**TOWN OF MOUNTAIN VILLAGE  
REGULAR DESIGN REVIEW BOARD MEETING AGENDA  
THURSDAY FEBRUARY 1, 2024, 10:00 AM  
MOUNTAIN VILLAGE TOWN HALL  
455 MOUNTAIN VILLAGE BLVD, MOUNTAIN VILLAGE, COLORADO  
TO BE HELD HYBRID THROUGH ZOOM:  
<https://us06web.zoom.us/j/86027664518>  
Meeting ID: 860 2766 4518**

**TO:** Mountain Village Design Review Board  
**FROM:** Claire Perez, Planner II  
**FOR:** Design Review Board Public Hearing; February 1, 2023  
**DATE:** January 15, 2023  
**RE:** Staff Memo – Initial Architecture and Site Review (IASR) Lot 1 Unit 1, TBD Eagle Drive.

**A4.2**

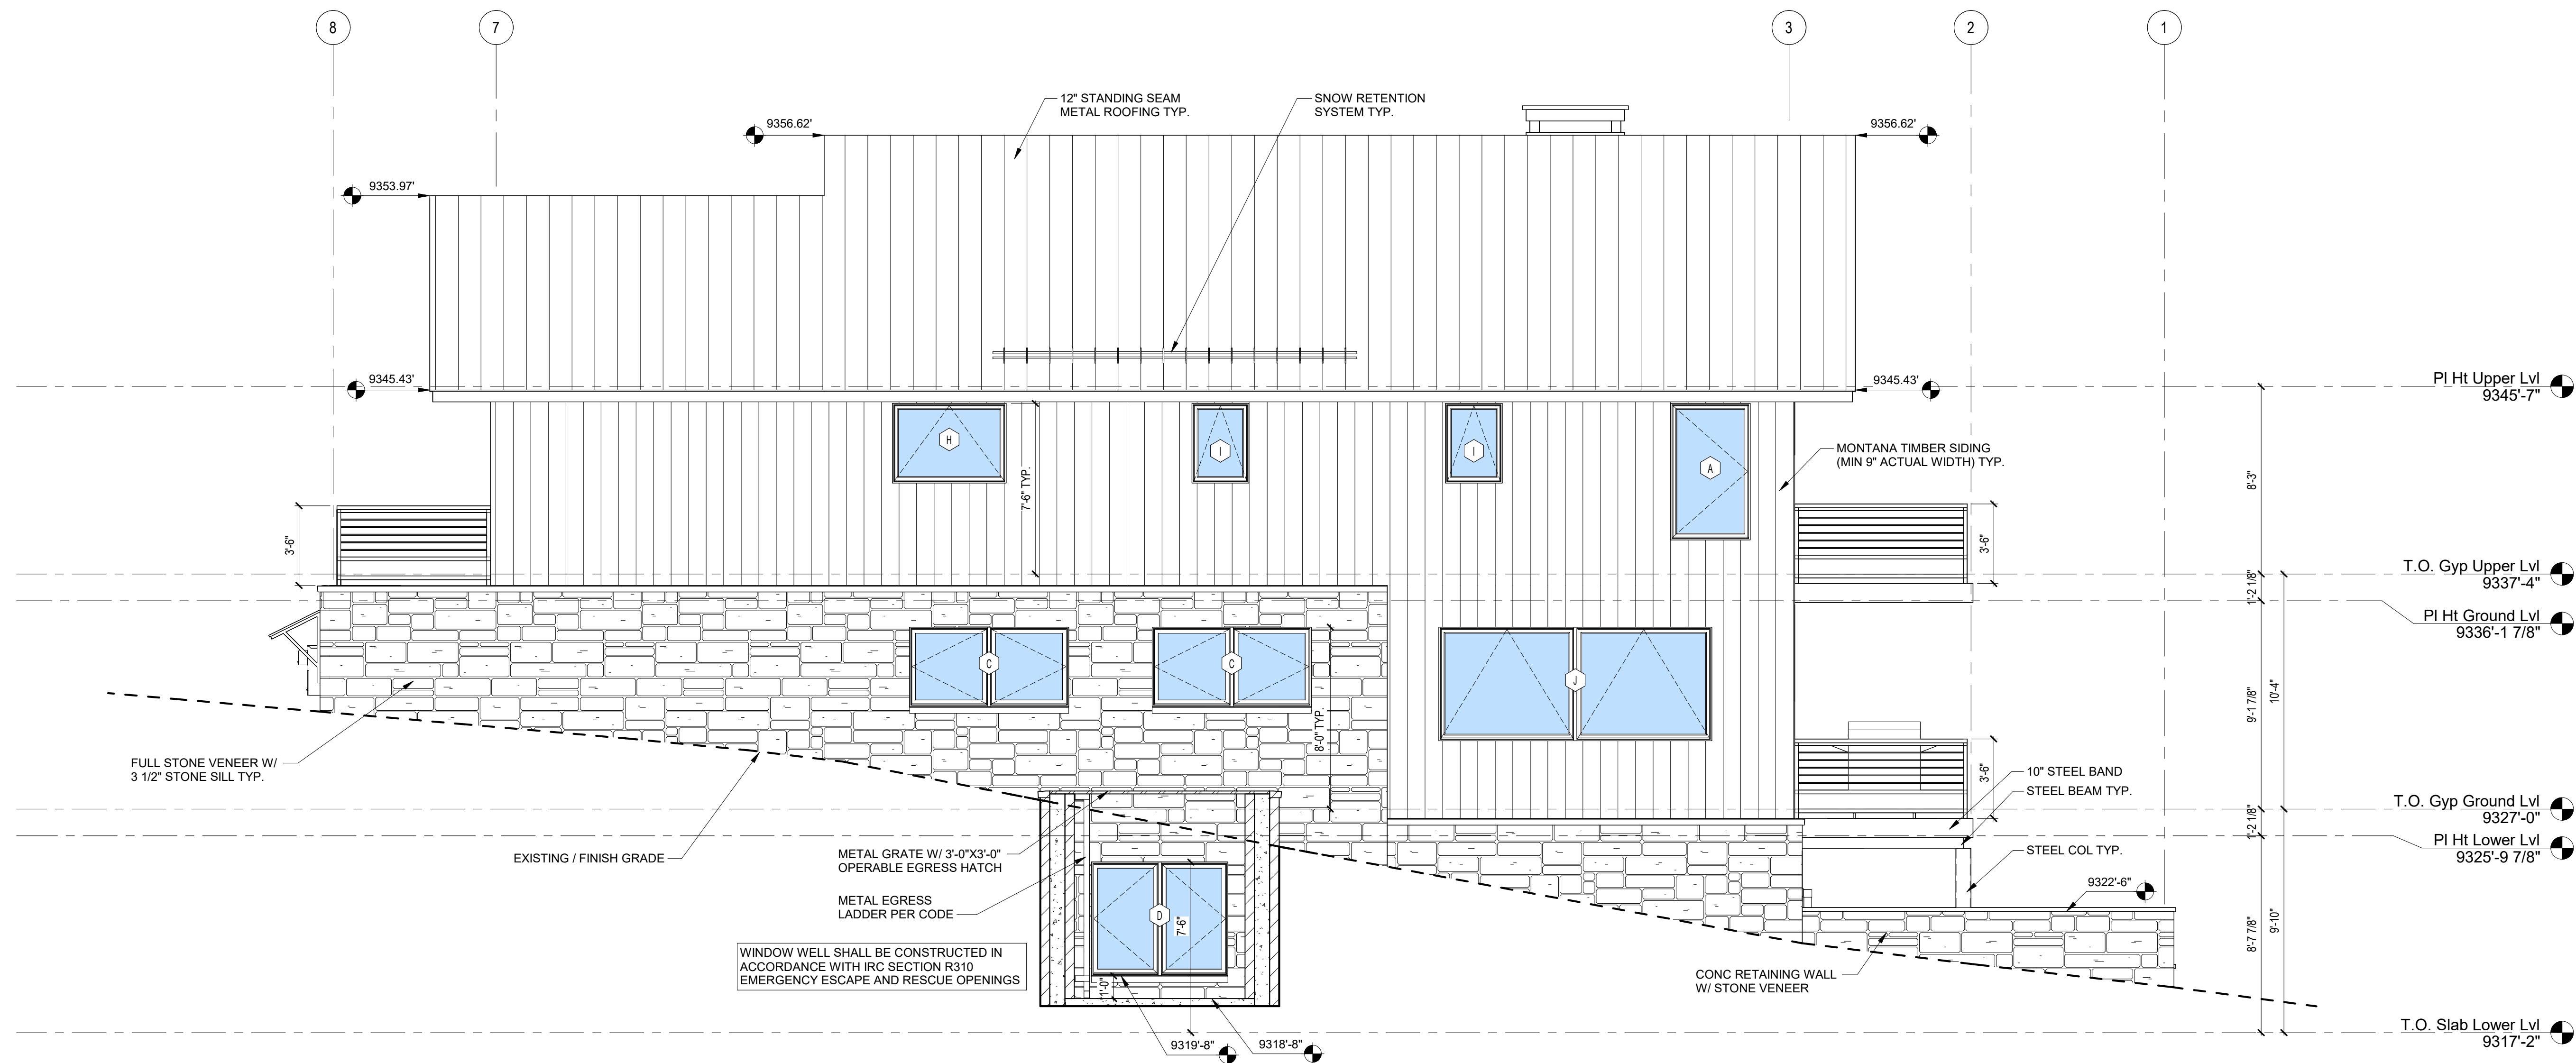
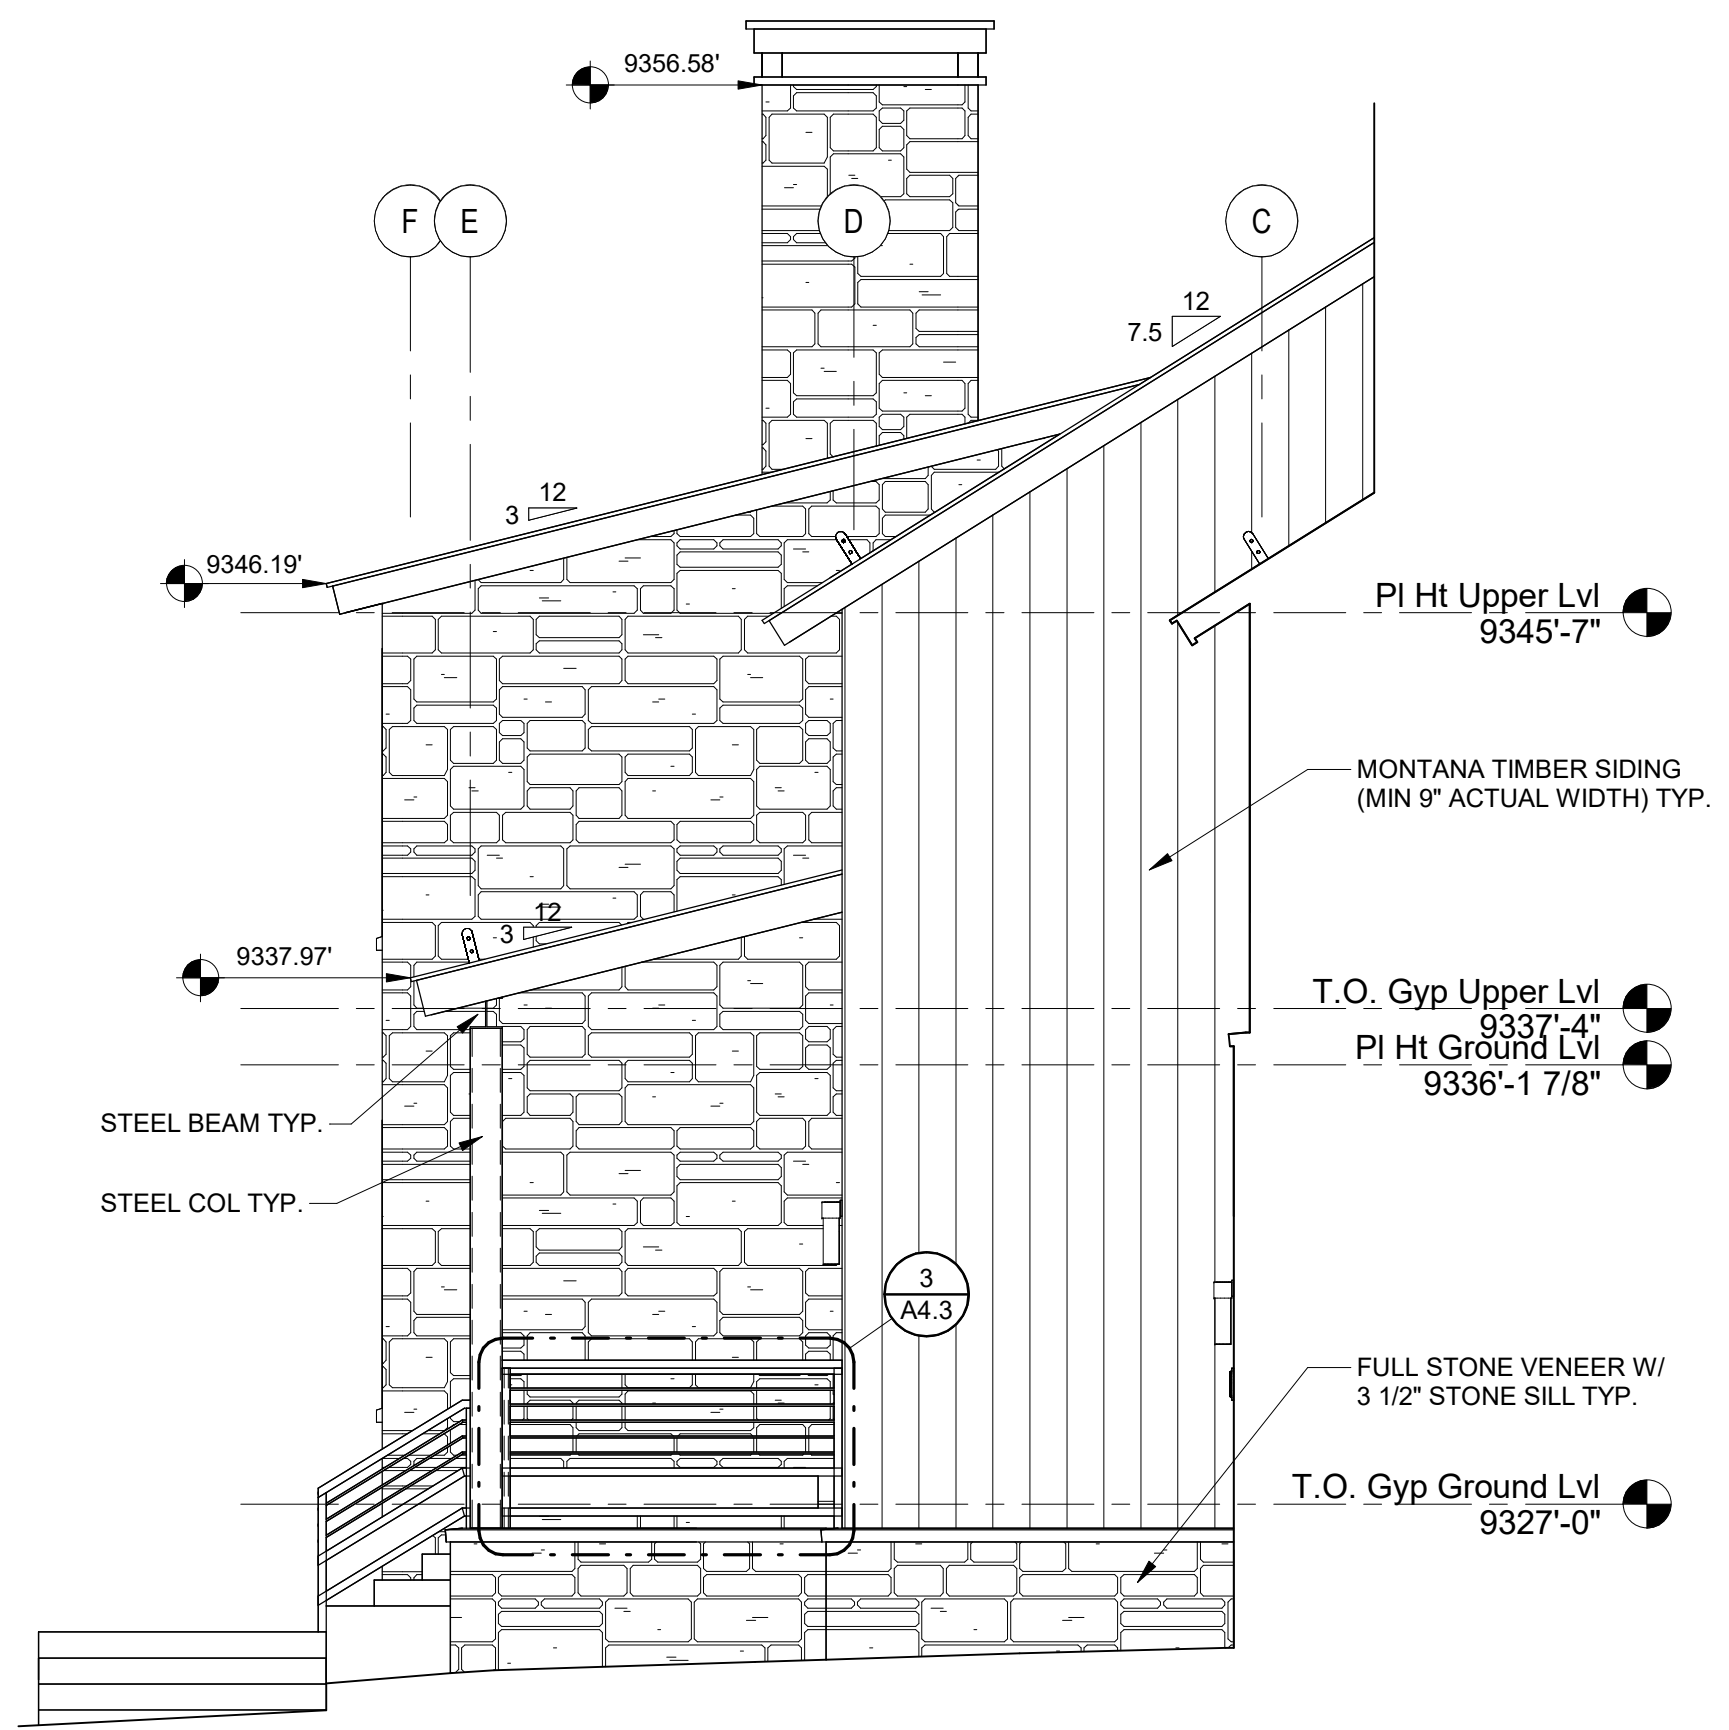
*Staff: Staff has determined that the primary roof form for the home is a gable roof and therefore is granted a maximum height of 40' and an average height of 35'. The applicant has calculated a maximum height of 39.96' and an average height of 25.31'. The CDC allows chimneys and similar structures to extend 5' past the maximum building height. The chimney cap height is shown as 2'-10" on sheet A4.2 Staff finds this criteria met.*
